UNITED STATES  
NUCLEAR REGULATORY COMMISSION

MEMORANDUM FOR: Docket File No. 40-8964  
FROM: Joel P. Grimm, Project Manager  
SUBJECT: SAFETY EVALUATION REPORT (SER): RIO ALGOM MINING CORP.,  
SMITH RANCH COMMERCIAL ISL LICENSE

SAFETY EVALUATION REPORT  
ACCOMPANYING ISSUANCE OF A  
SOURCE MATERIAL LICENSE  
TO  
RIO ALGOM MINING CORPORATION  
SMITH RANCH ISL PROJECT  
CONVERSE COUNTY, WYOMING  
DOCKET NO. 40-8964  
SOURCE MATERIAL LICENSE NO. SUA-1548

Figure 4.2 - Proposed floor plan and monitoring locations for airborne radon daughters and uranium in the commercial processing plant.

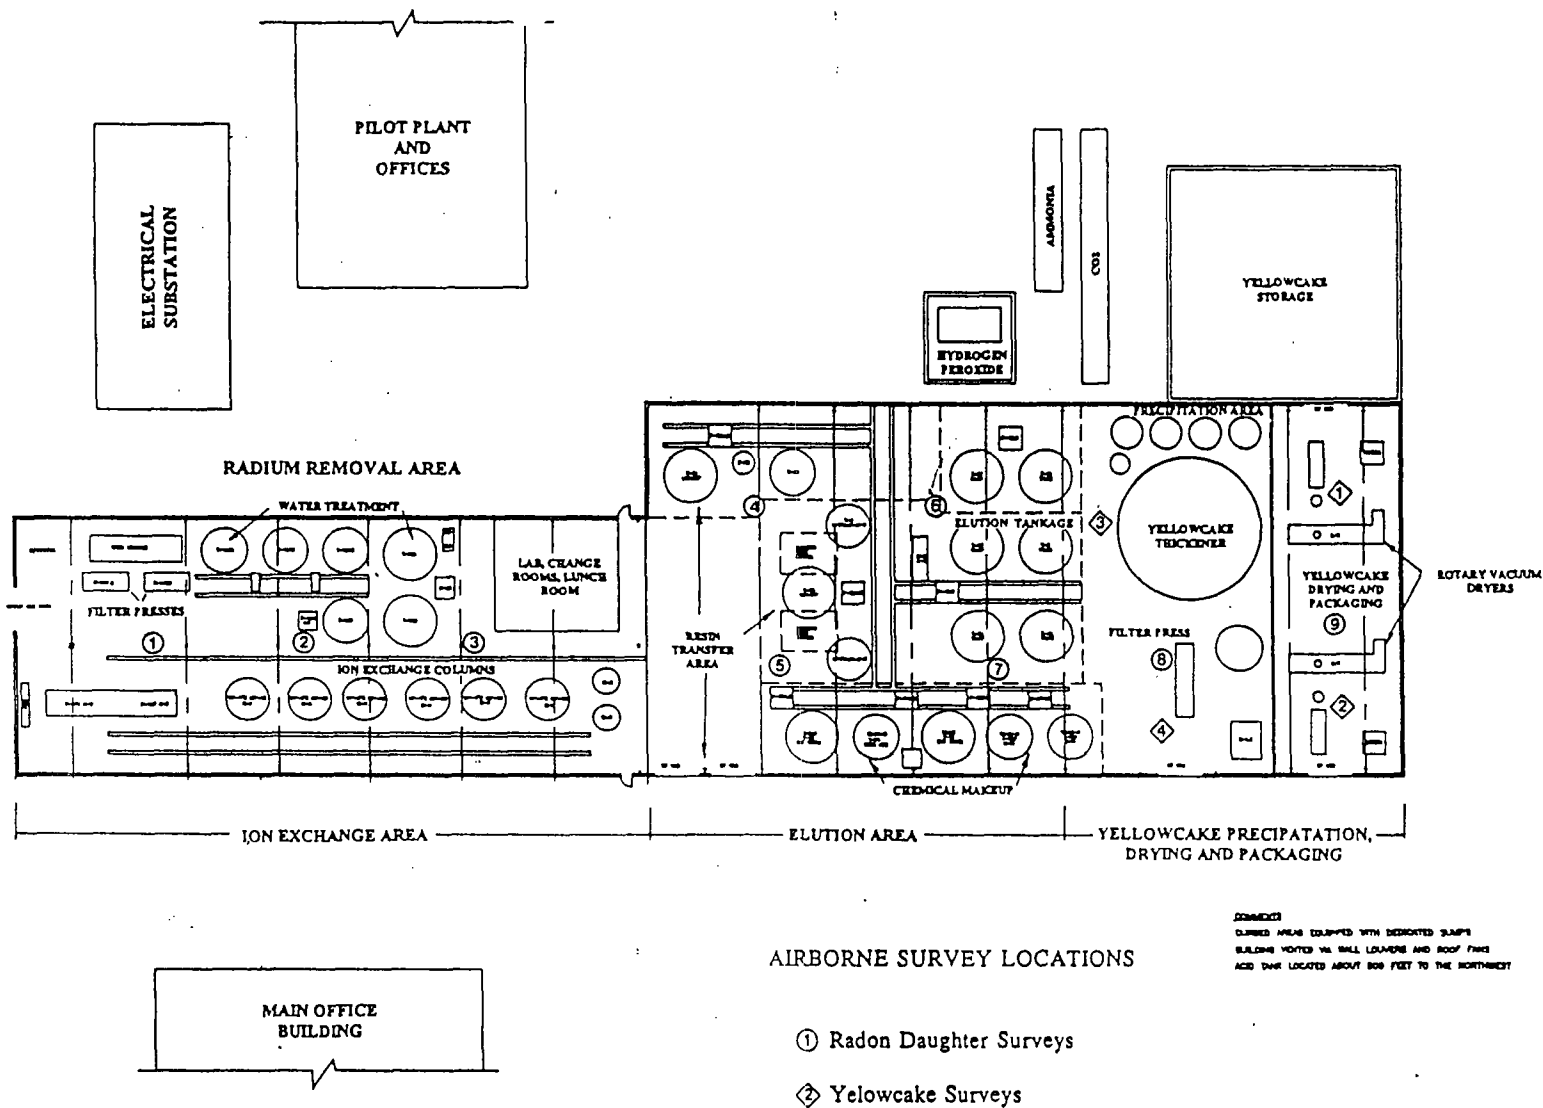
Rio Algom proposes to use several airborne radionuclide sampling techniques to determine personnel exposure to uranium-bearing dust. Area monitoring at four plant locations (Figure 4.2) will provide the main approach to determining personnel exposures. Areas associated with yellowcake activities are sampled monthly. Any nonroutine work or maintenance where exposures to airborne particulates may be elevated will require personal air samplers. Radon daughter sampling will be conducted at an additional nine locations as shown on Figure 4.2.

- ° The licensee shall perform monthly surveys for natural uranium and radon progeny as shown in Figure 9-2 of the licensee's application dated March 31, 1988, as amended. In addition, the licensee shall conduct spot surveys to confirm the adequacy of the yellowcake and radon progeny monitoring plan. If radon or radon progeny concentrations exceed 8 picocuries per liter (pCi/l) or 0.08 working level (WL), respectively, sampling shall be weekly until 4 consecutive weekly samples exhibit less than 8 pCi/l or 0.08 WL.

Figure 4.3 - Proposed floor plan and monitoring locations for gamma radiation in the commercial processing plant.

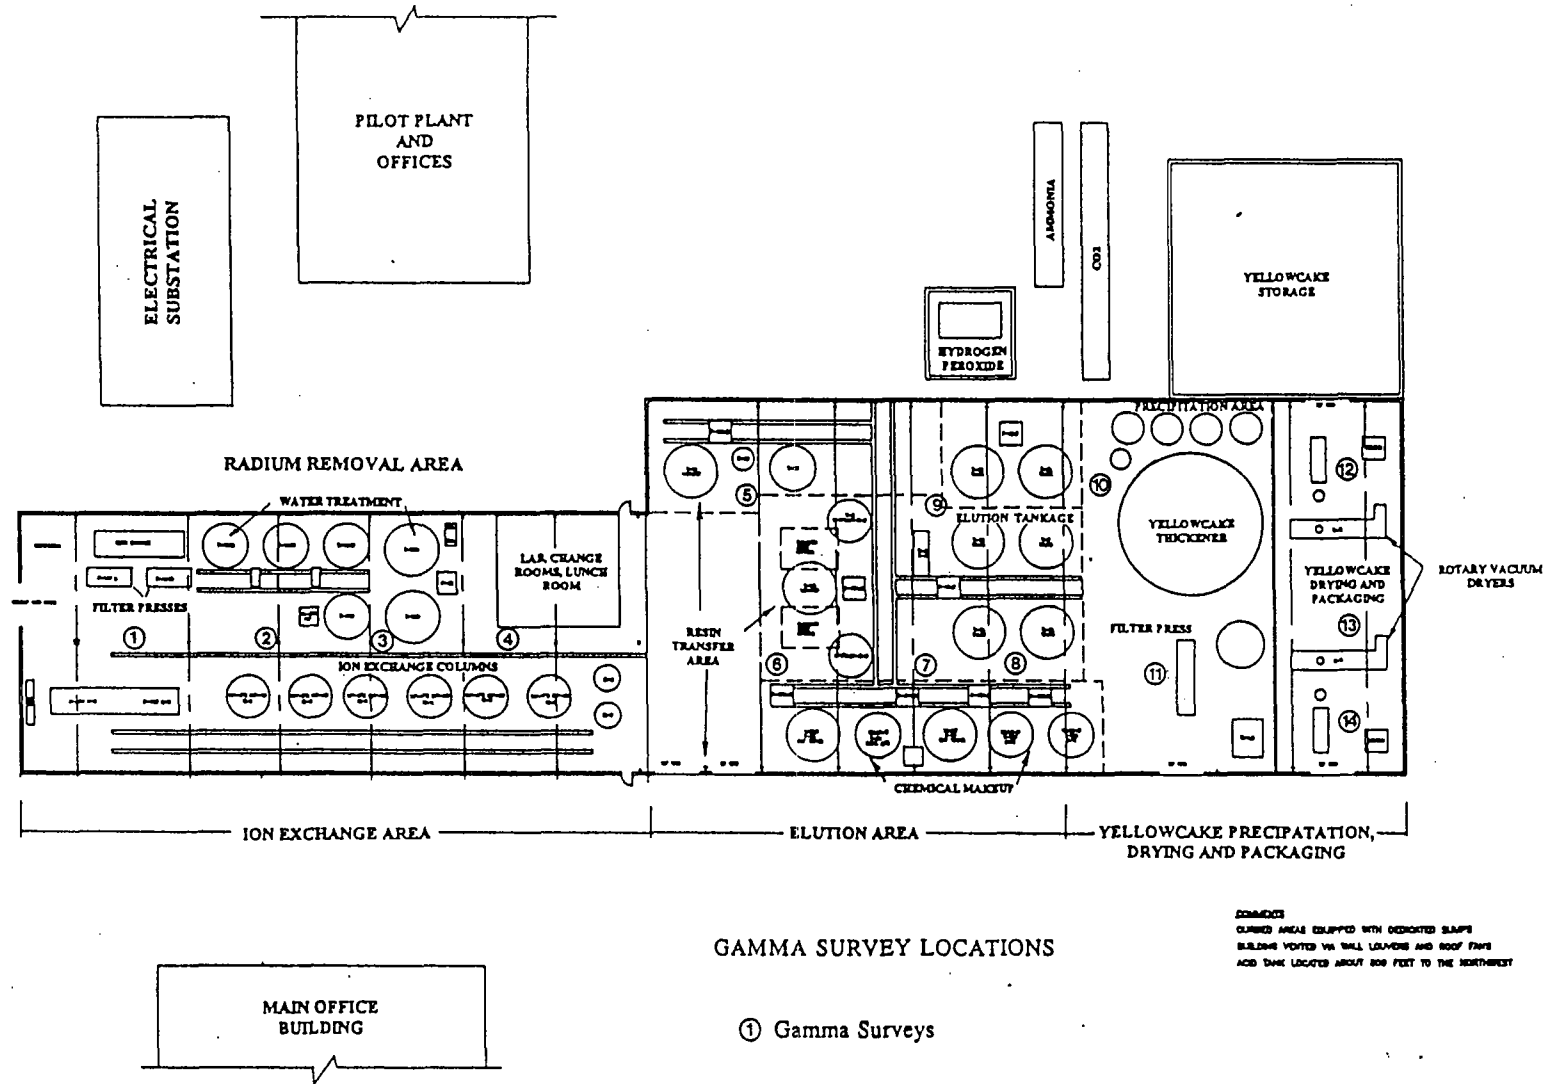
In addition to personal TLD monitoring, Rio Algom will be required by license condition to evaluate the results of a quarterly gamma survey in the locations specified in Figure 4.3. The evaluation will identify any areas which require posting as radiation areas. Operational records indicate that the areas surrounding the IX columns and yellowcake storage may require posting.

- The licensee shall perform quarterly gamma radiation surveys in enclosed areas at the locations specified in Figure 9-3 of the licensee's application dated March 31, 1988, as amended. In addition, the licensee shall conduct spot checks to confirm the adequacy of the gamma radiation monitoring plan.
- The licensee shall perform monthly alpha contamination surveys of the facility laboratory and offices and weekly surveys of eating and change areas, as specified in licensee's application dated March 31, 1988, as amended. If samples are analyzed in the facility laboratory, the licensee shall survey all surfaces used for urine sample preparation preceding the analyses as specified in Section 3.5 of Regulatory Guide 8.31.
